REMEDIATION SYSTEM EVALUATION

SUMMITVILLE MINE SUPERFUND SITE SUMMITVILLE, COLORADO

Report of the Remediation System Evaluation,
Site Visit Conducted at the Summitville Mine Superfund Site
June 12-13, 2002

EPA 542-R-02-018
September 2002
www.epa.gov/tio
clu-in.org/optimization

FIGURE 2. SITE LAYOUT SHOWING MAJOR FEATURES, INCLUDING SUB-BASINS, DRAINAGE DITCHES, AND DIVERSIONS.

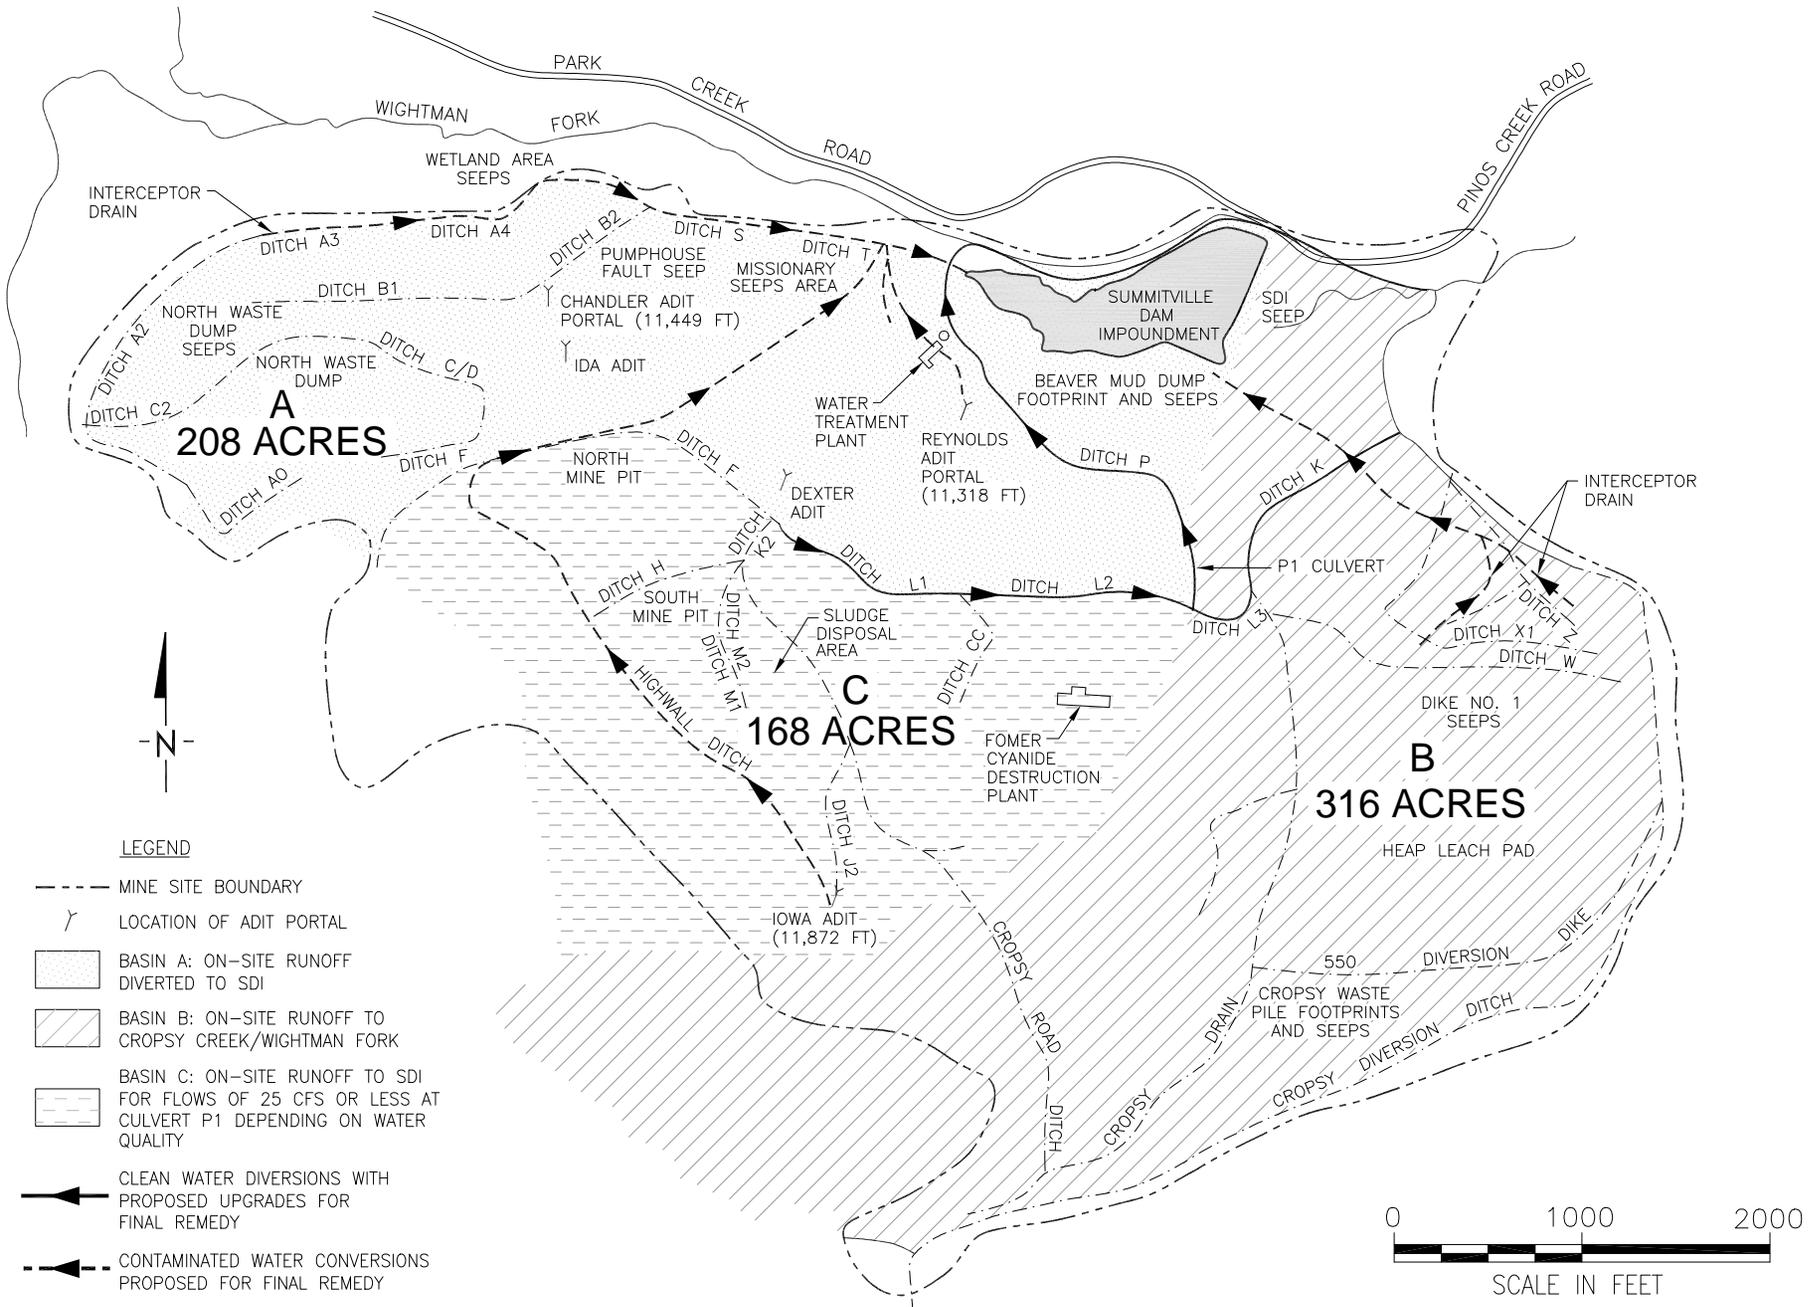
- As part of further groundwater and seep management, the site managers should conduct a hydrogeological evaluation to determine if the planned interceptor trench along the northern boundary of the site will provide the expected capture of impacted water. Due to flow in both the alluvium and the bedrock, potential exists for flow to bypass the planned interceptor trench. A more effective approach may involve letting the impacted water continue to drain into the valley and diverting this drainage to the impoundment while diverting clean water around this area.

Knight Piésold has been contracted with design and installation of the water management structures for the final remedy. Their work will include diverting unimpacted surface runoff from the site and capturing impacted groundwater seeps that are currently discharging to Wightman Fork. The following three interceptor drains/trenches (depicted on Figure 2) are proposed for the site to divert impacted water to the SDI:
